TENDER 16-20

WATER TREATMENT BUILDING

ADDENDUM NO. 3

September 30th, 2016

TITLE:	PROPOSED RAW WATER SUPPLY MAIN HIGHWAY #28 TREATMENT BUILDING - CONTRACT 2 EXISTING CONDITIONS	DRAWING NO.	15-508- C100
		PROJECT:	112311316
		REV.	1

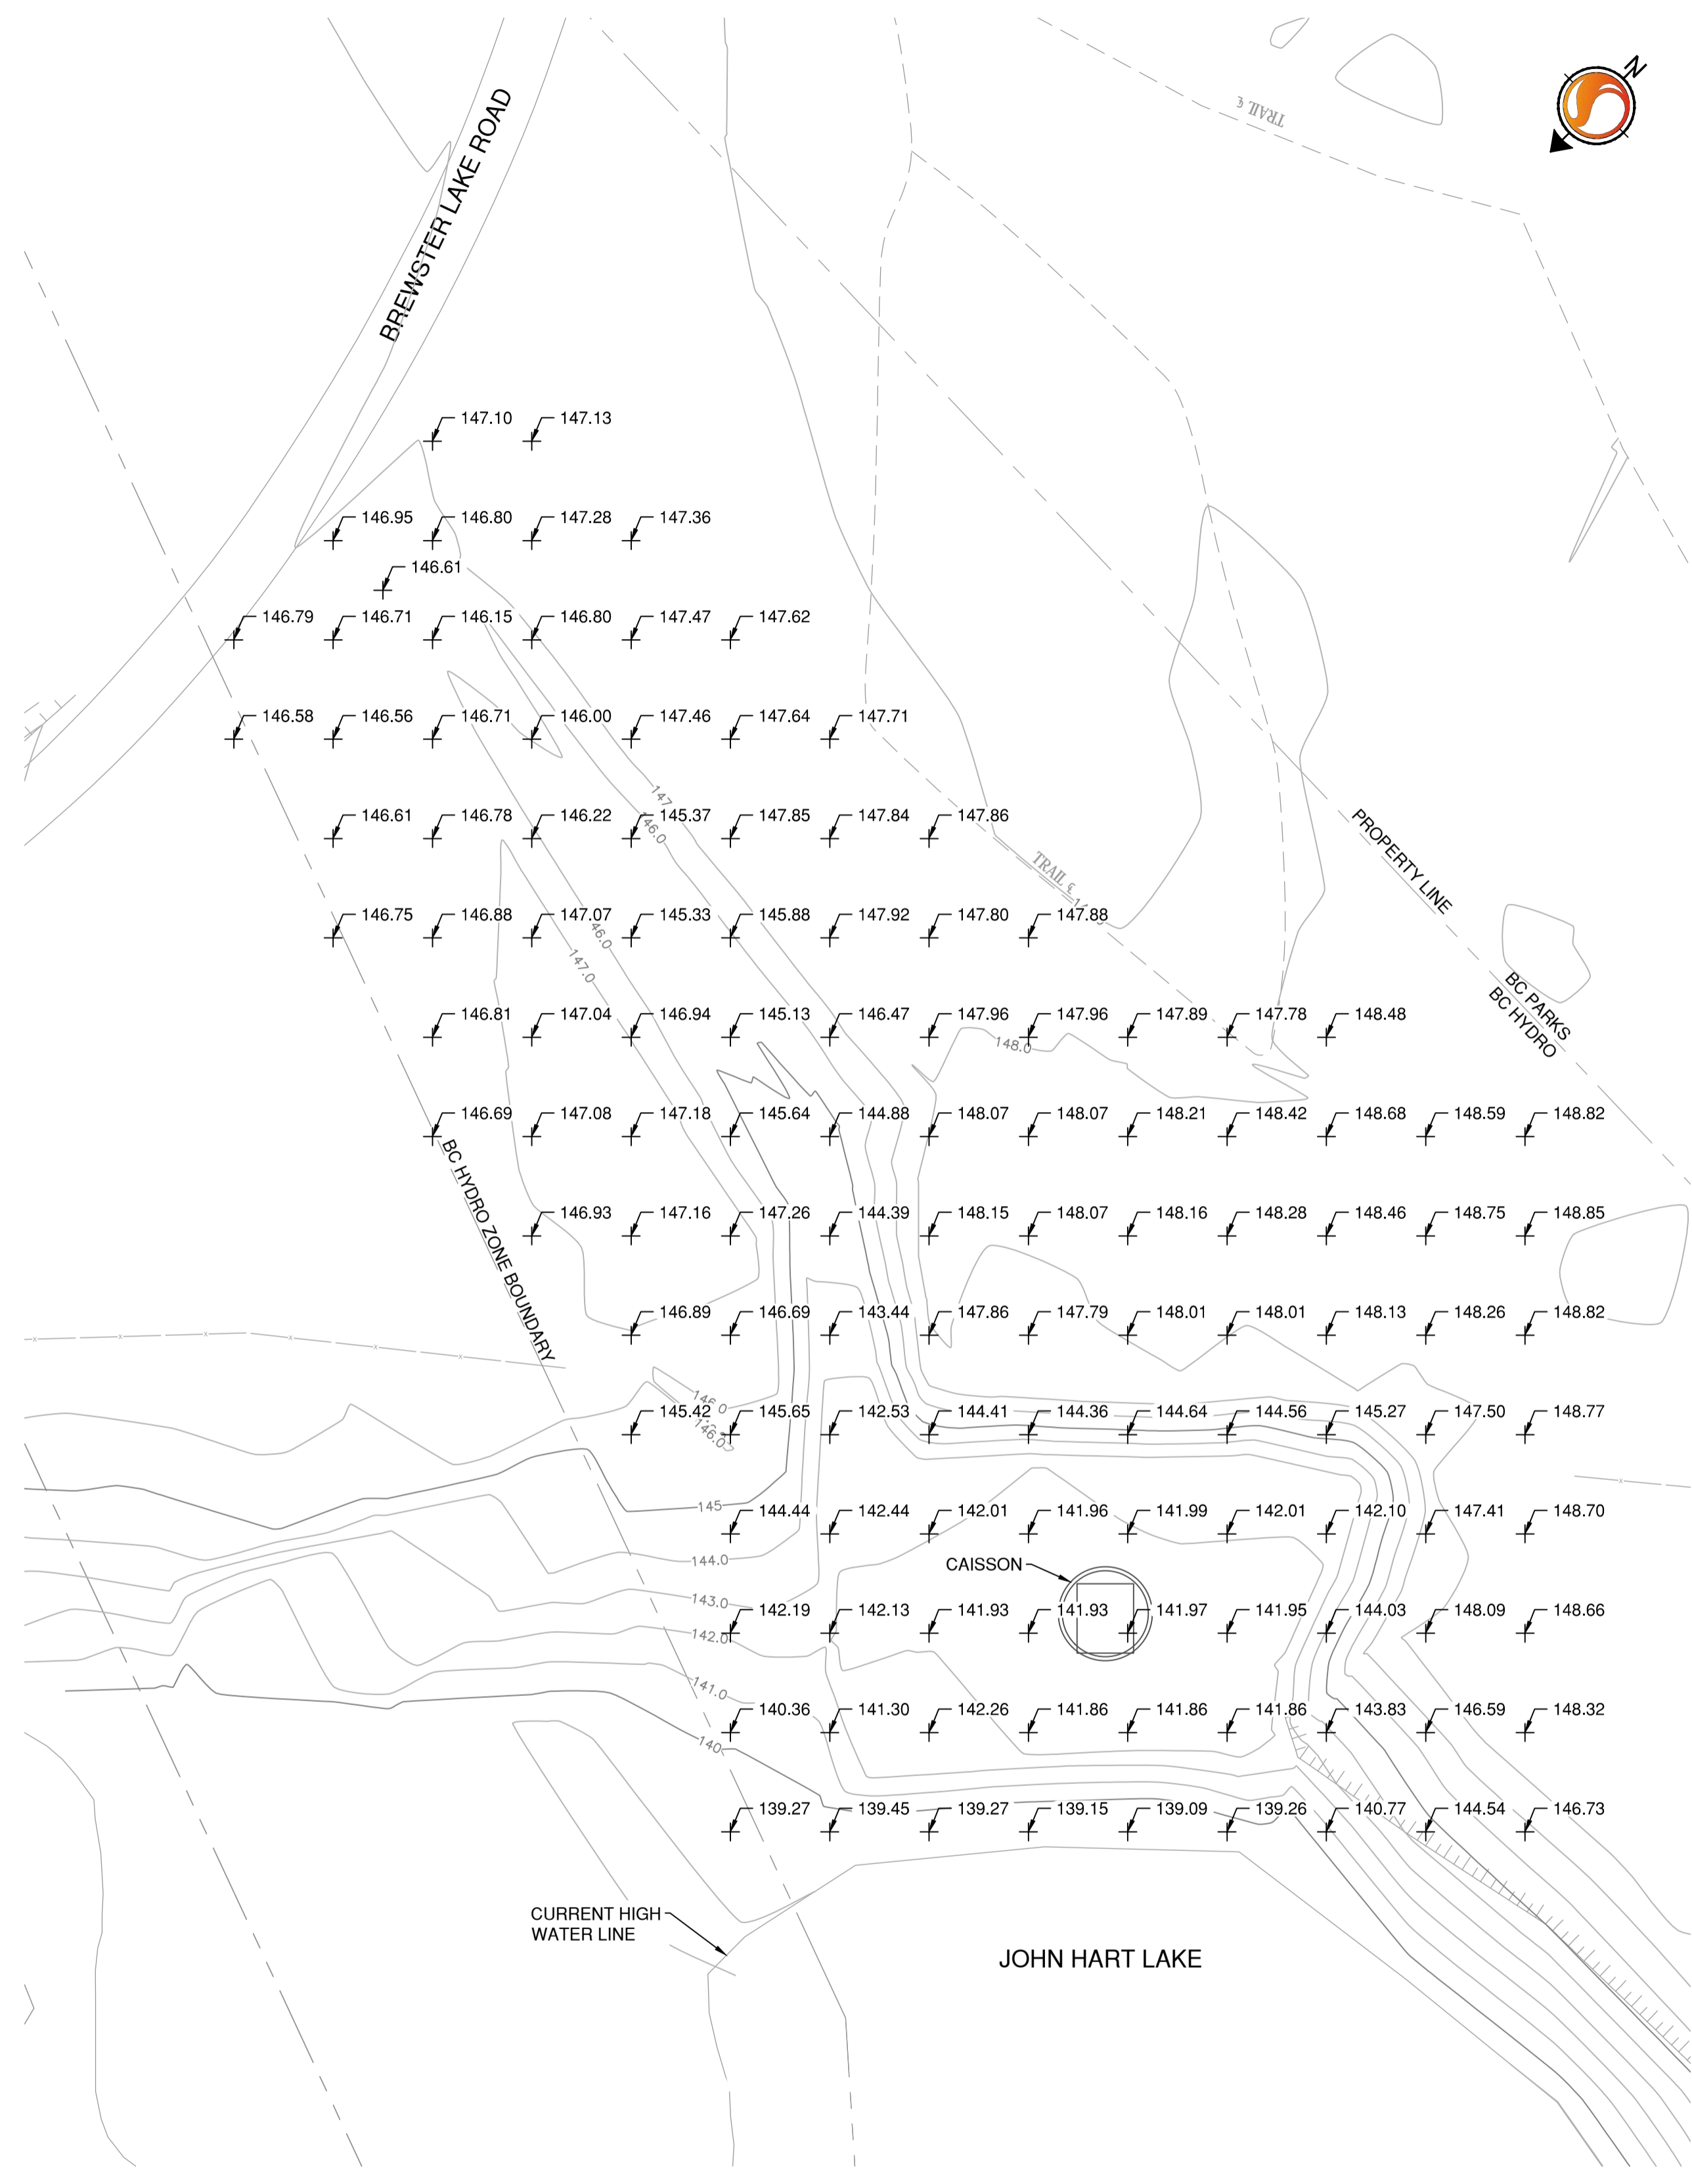
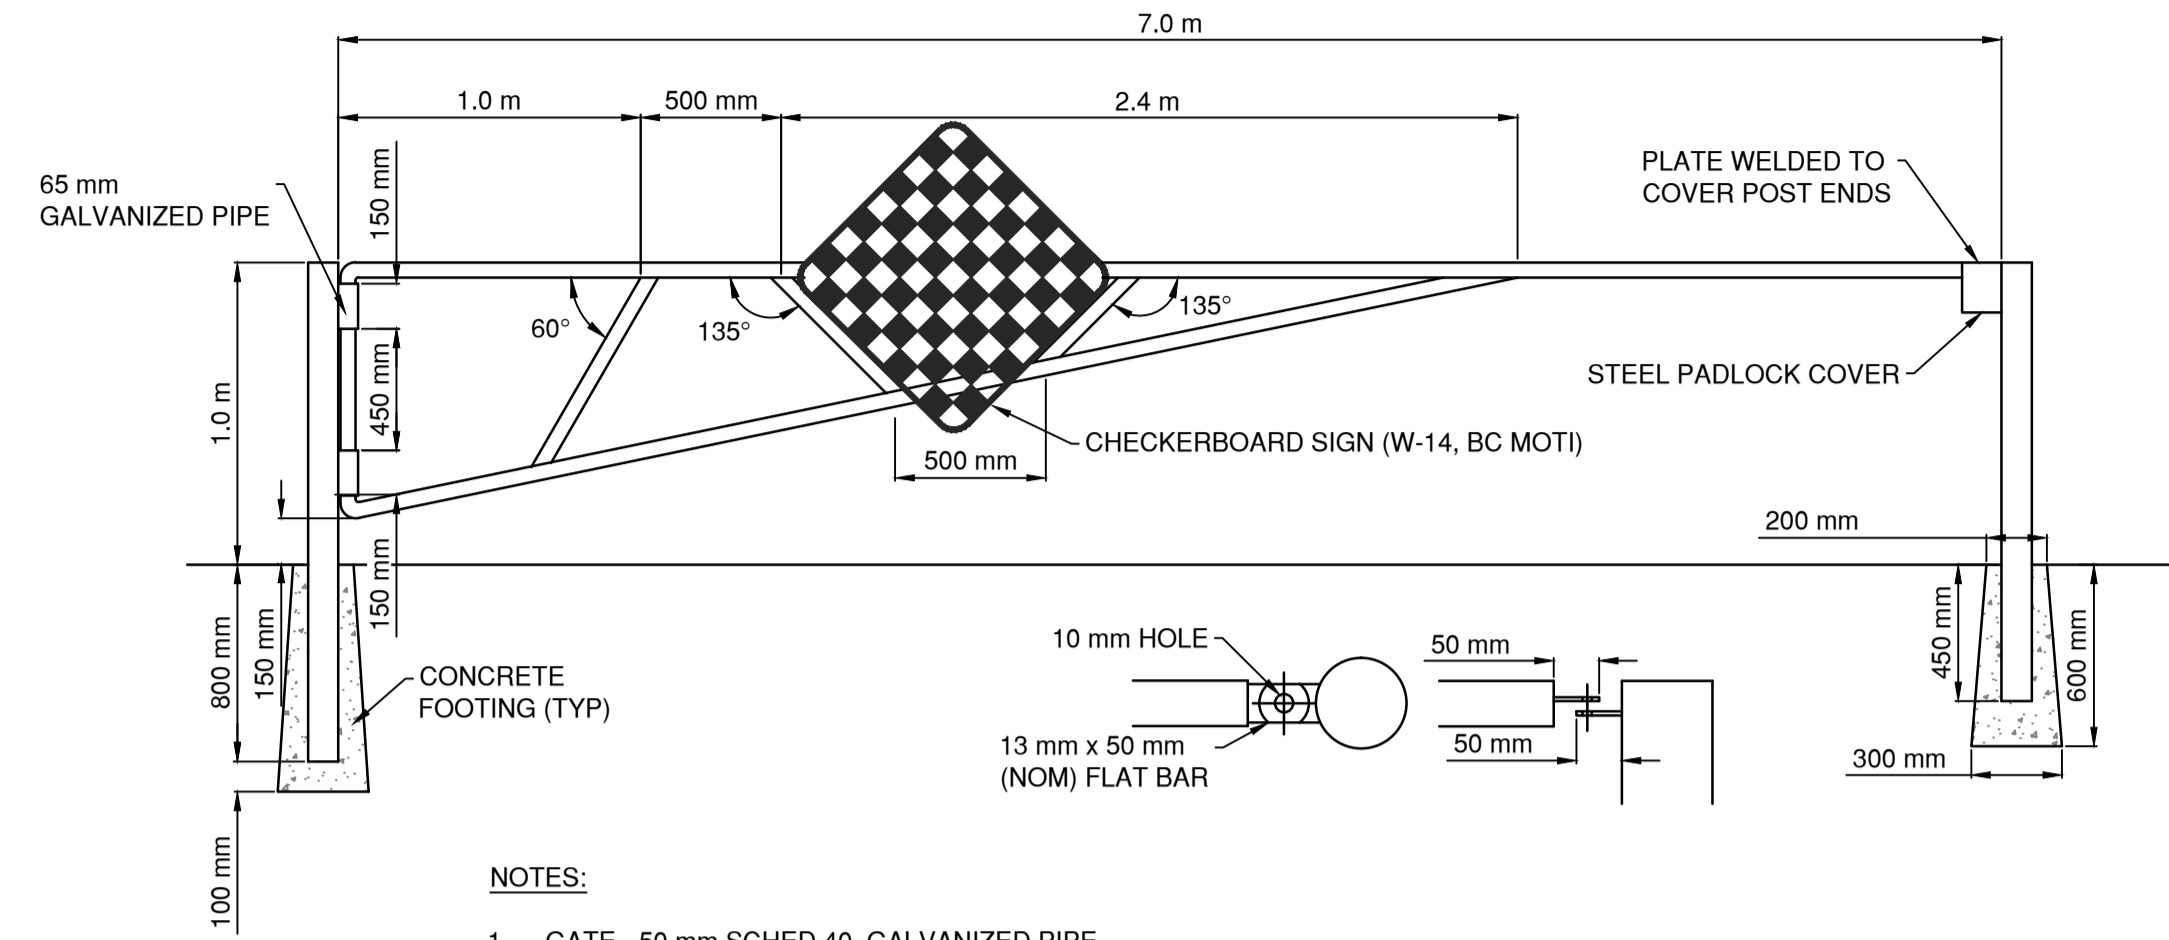
Item 1.2.5 of Section 01 12 00 states "Once contract 1 is complete, or near a state of completion, a survey of the site will be conducted by the City and the information provided to the contractor. This information will be made available as an addendum". Is a recent site survey available to assist in determining the extent of site clearing/stripping and excavation required?

It appears that existing grade elevations do not match existing elevations provided on the Civil drawings. As we do not have full access to the site at this time please confirm these elevations are accurate.

With reference to Drawing C102 and Sections A,B,C/C104 it appears existing ground as drawn is considerably higher than what we are seeing in the field. It is our understanding the contractor currently working at the site has taken the grade down to approximately elevation 142.0 in some areas but not the entire building envelope. Can we get a plan or sections that show where the site subgrade will be at commencement of this contract.

Existing conditions drawing has been provided in Addendum 3.

Existing conditions drawing has been provided in Addendum 3

Existing conditions drawing has been provided in Addendum 3

TITLE: PROPOSED RAW WATER SUPPLY MAIN HIGHWAY #28 TREATMENT BUILDING - CONTRACT 2	DRAWING NO. 15-508- C302
CIVIL DETAILS	PROJECT: 11231316
	REV. 2

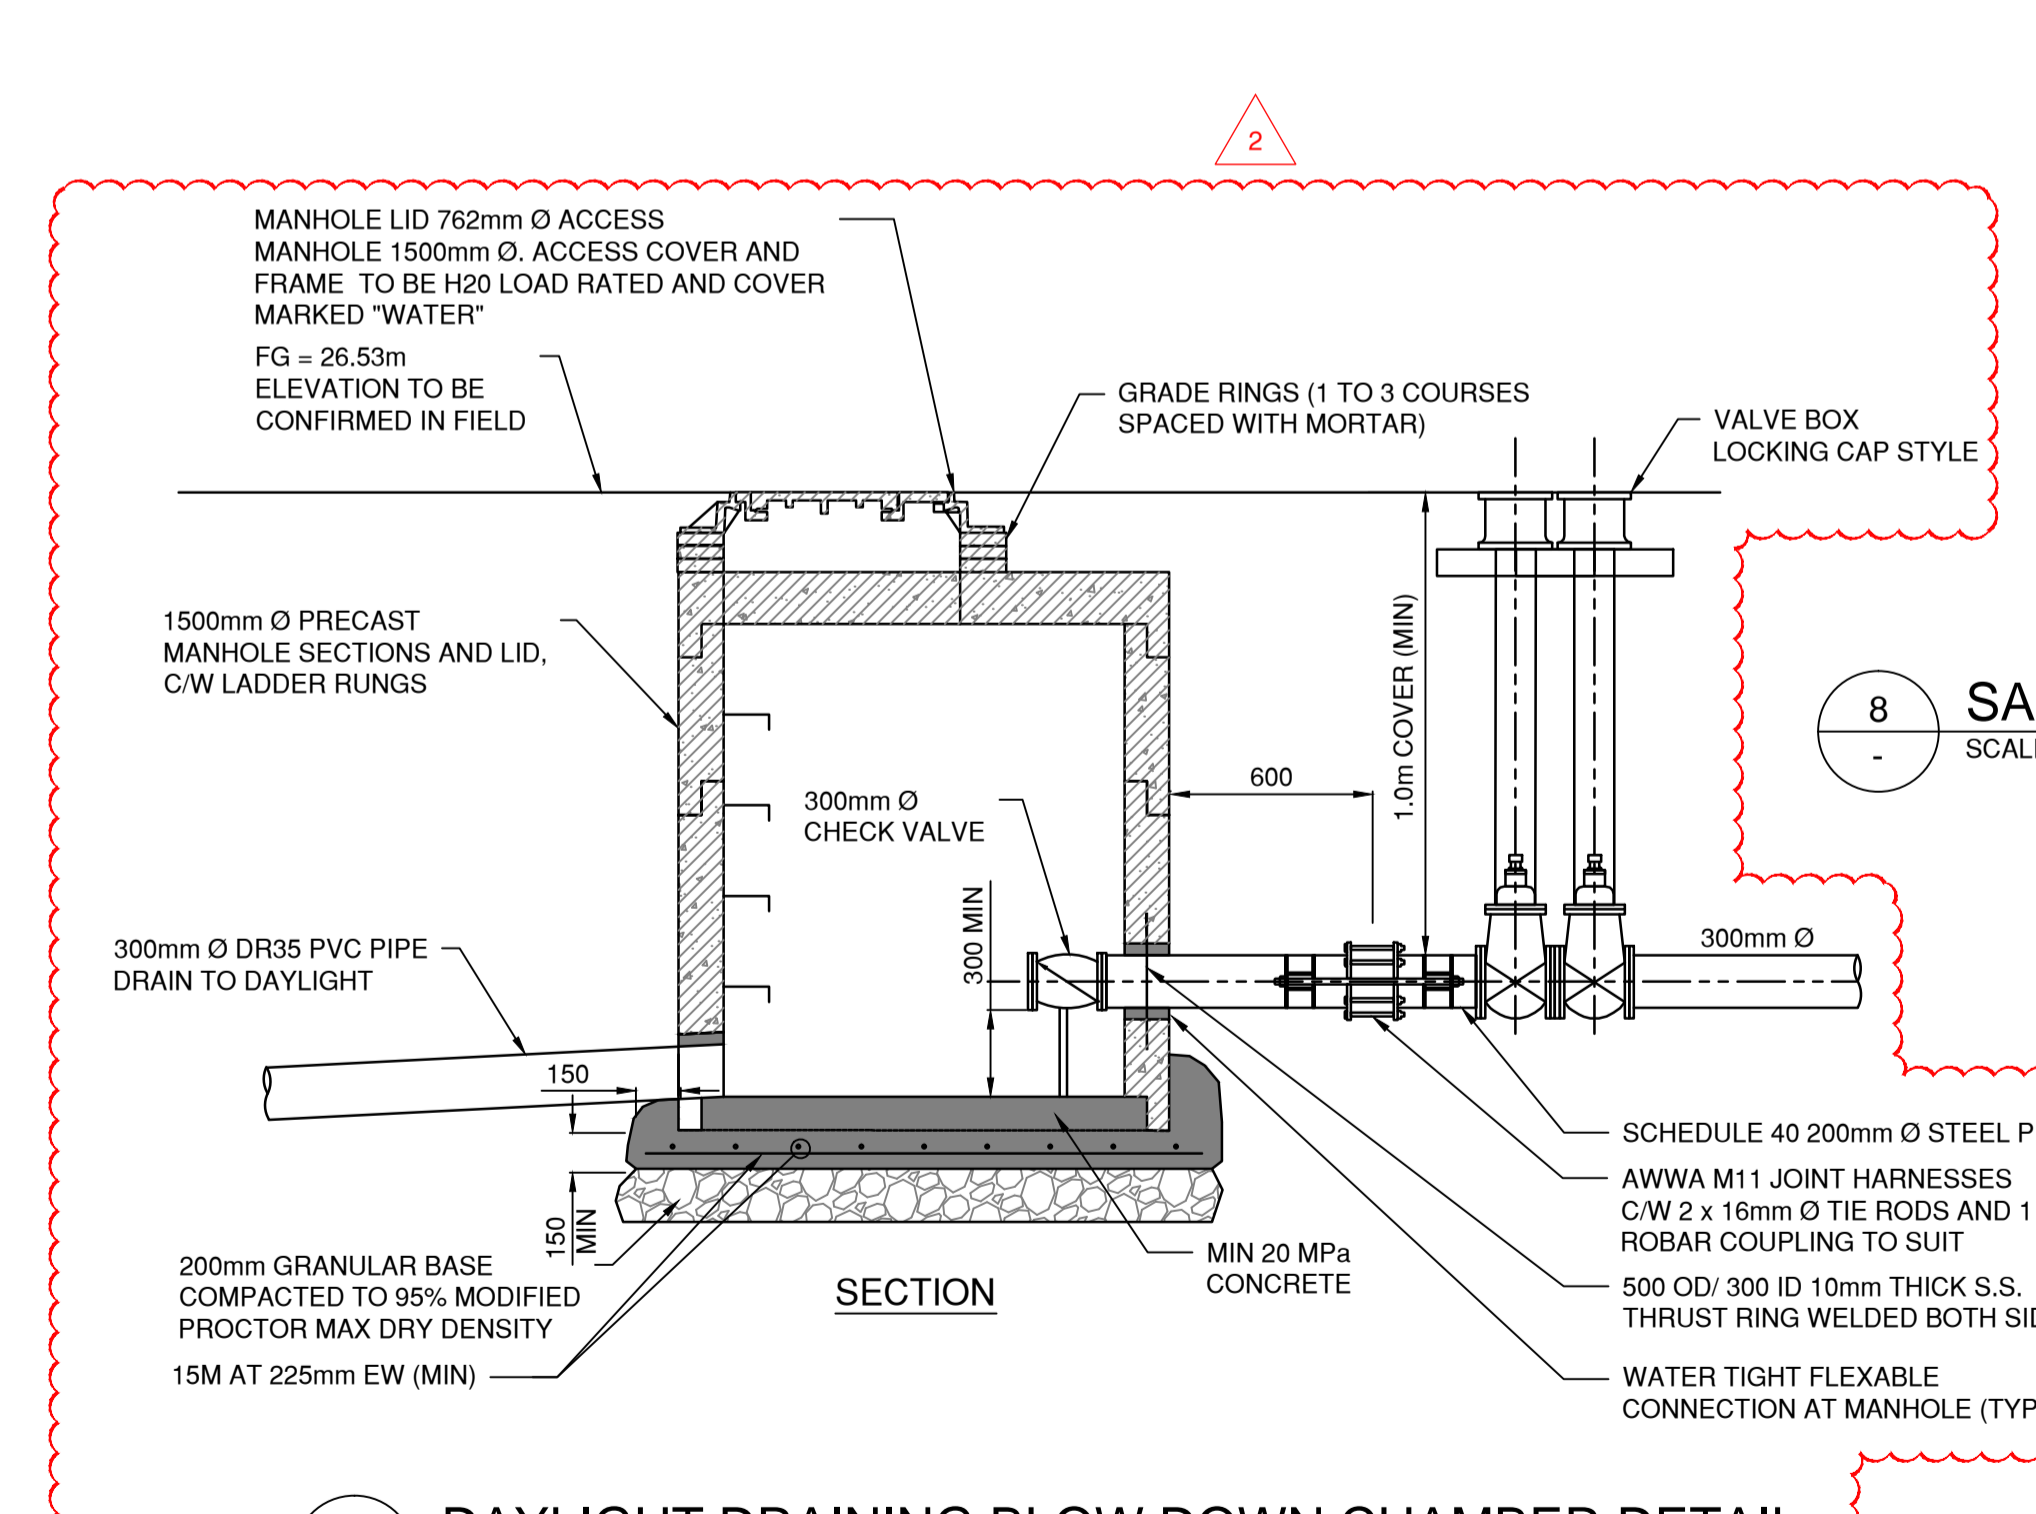
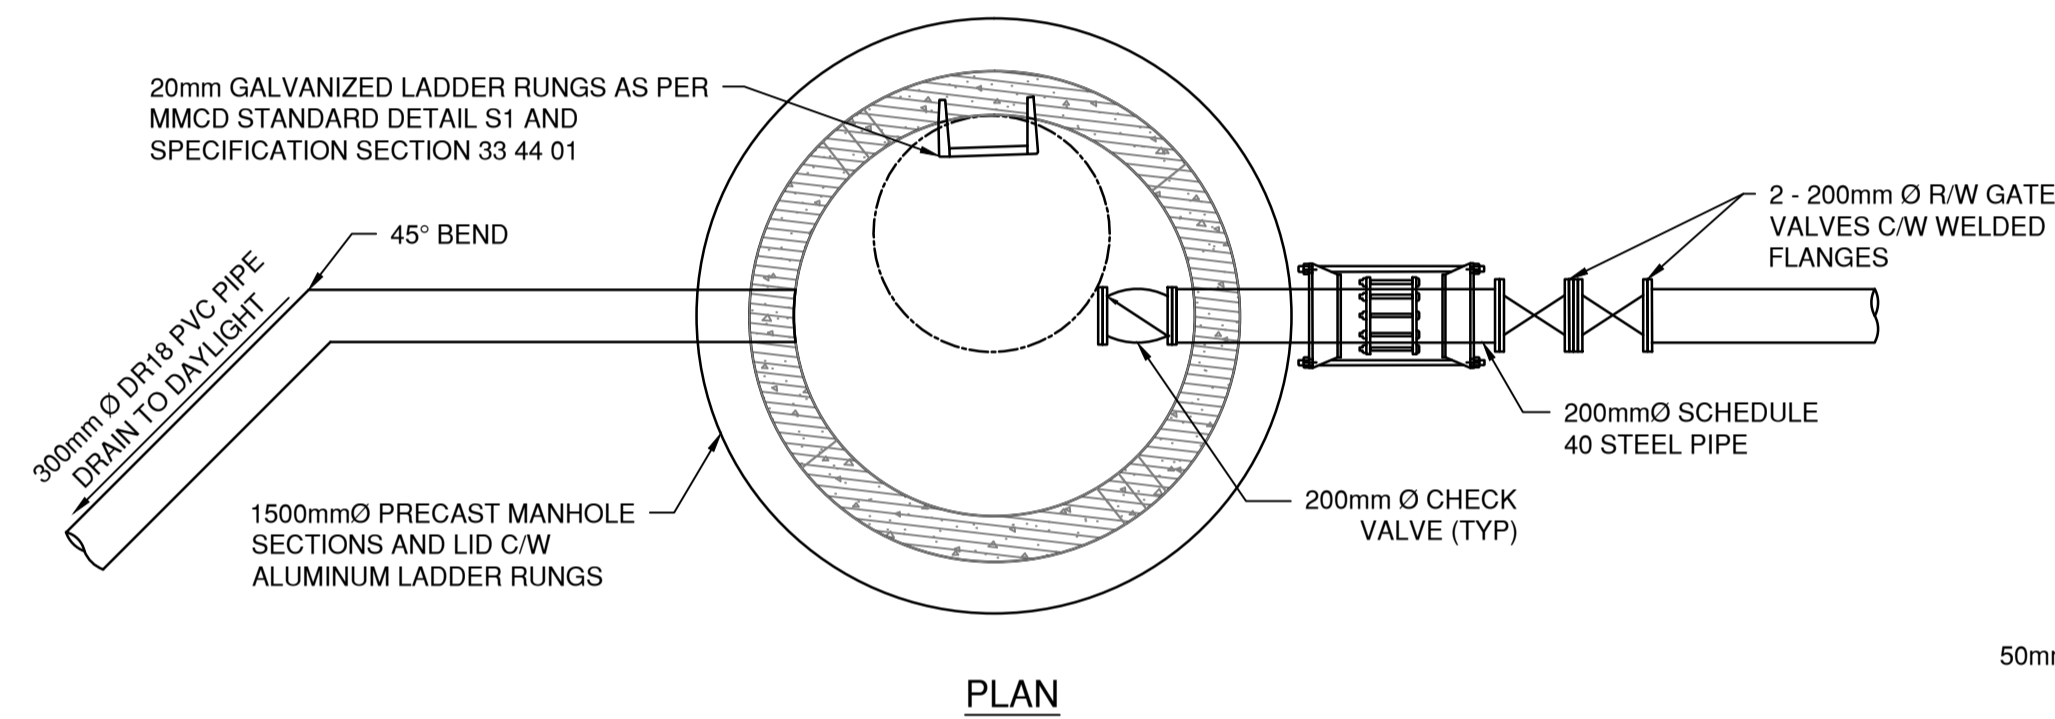
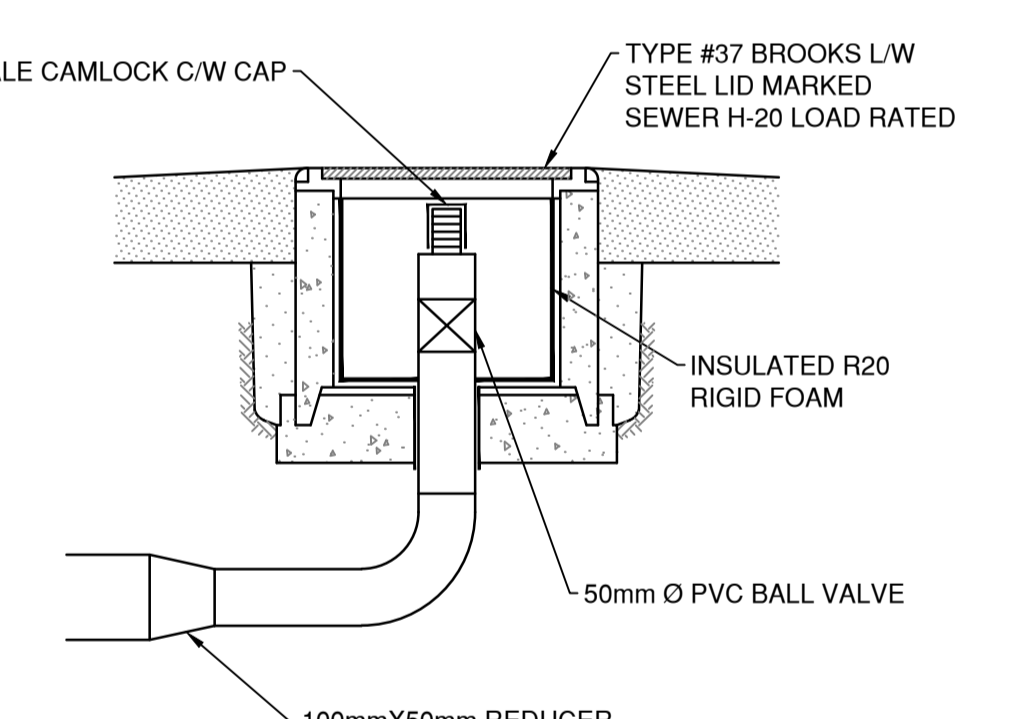
The detail on C302 for the blowdown shows 300mm pipe and 200mm gates and check valve. Please clarify.

Drawing has been updated to reflect 300mm valves
